SUBJECT: REVIEW OF PRELIMINARY ACCIDENT SEQUENCE PRECURSOR ANALYSIS OF EVENT
AT COMANCHE PEAK STEAM ELECTRIC STATION, UNIT 1

LER No. 445/95-003, -004

Licensee Comments

Fig. 2 Fault tree modeling recoverable and nonrecoverable failures for the failure to trip.

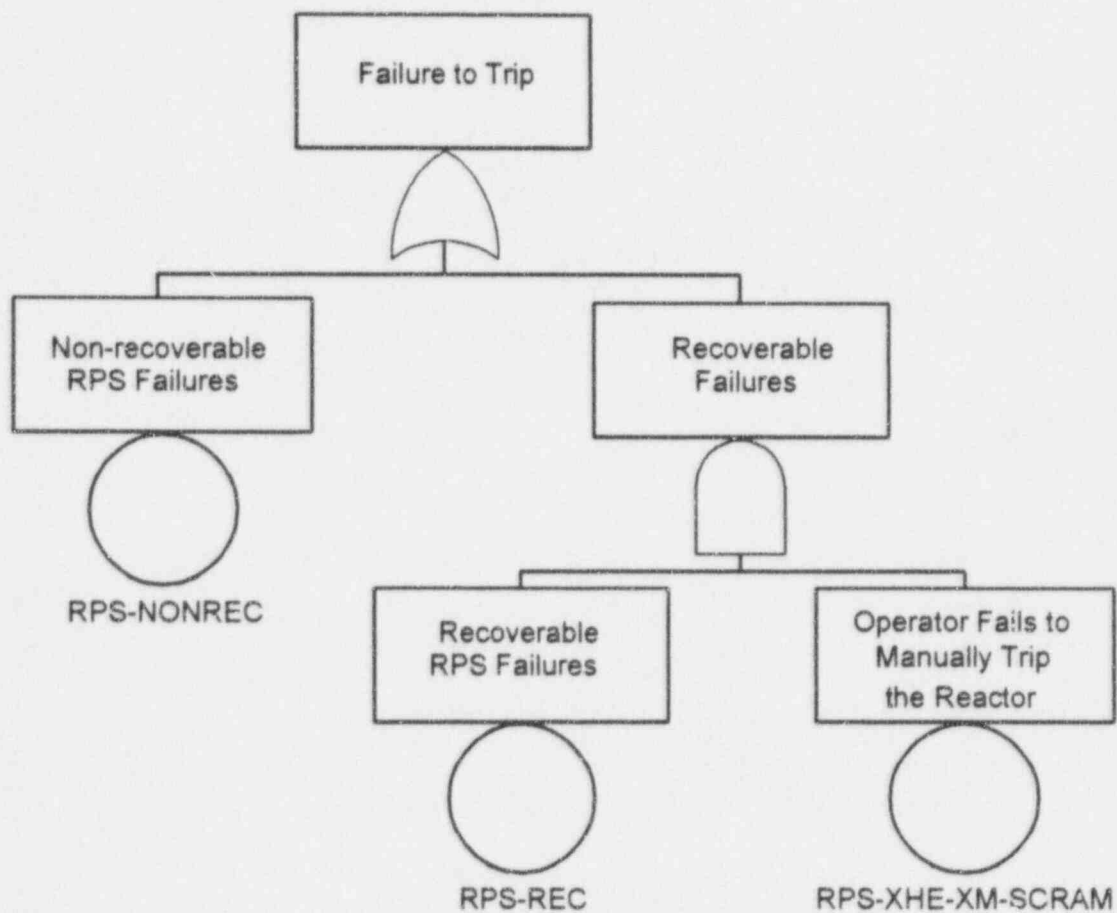
The failures in this event increase the potential significance of failure to trip/ATWS sequences. To model potential reactor trip failures more accurately, the reactor trip model was modified (as shown in Fig. 2) to account for recoverable versus nonrecoverable RPS failures.
